i-STAT[®] TECHNICAL BULLETIN

i-STAT[®] G3+ LARGE THUMBWELL CARTRIDGE

OVERVIEW

LARGE THUMBWELL
G3+ CARTRIDGE

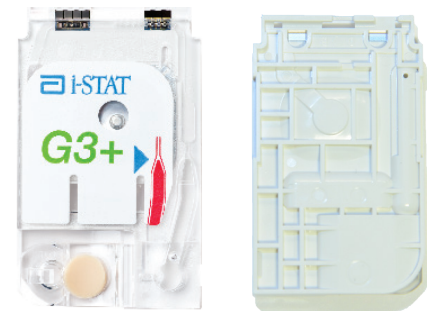
Currently, i-STAT G3+ cartridges are available with two different thumbwells. The product is being migrated to the newer cartridge, which contains the larger thumbwell feature.

The large thumbwell i-STAT G3+ cartridge **retains the intended use** of the original design. **Its performance characteristics are consistent** with those of the original G3+ cartridge and should be treated as a new lot number.

- The Abbott List Number for the G3+ cartridge will change to **03P78-50**.
- Storage and disposal instructions remain unchanged for the redesigned G3+ cartridge.
- Each box will continue to include 25 cartridges; however, the new box is smaller, helping to decrease storage space requirements.
- The cartridge will continue to be sealed in a foil pouch. The pouch will contain the same information as the original packaging.
- The large thumbwell G3+ cartridge is **not made with natural rubber latex**.

HIGH-CONTRAST SAMPLE WELL

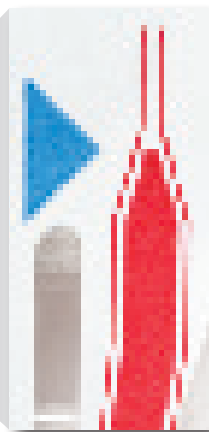
The large thumbwell G3+ cartridge features enhancements that foster **ease of use**:

ORIGINAL SAMPLE WELL

NEW SAMPLE WELL

RELOCATED FILL MARK INDICATOR

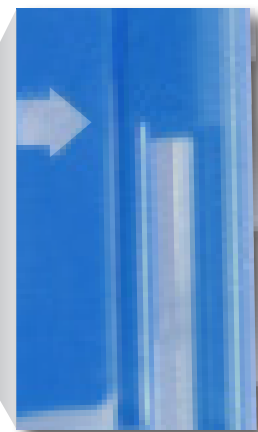
**OLD LOCATION OF
FILL INDICATOR**

**NEW LOCATION OF
FILL INDICATOR**
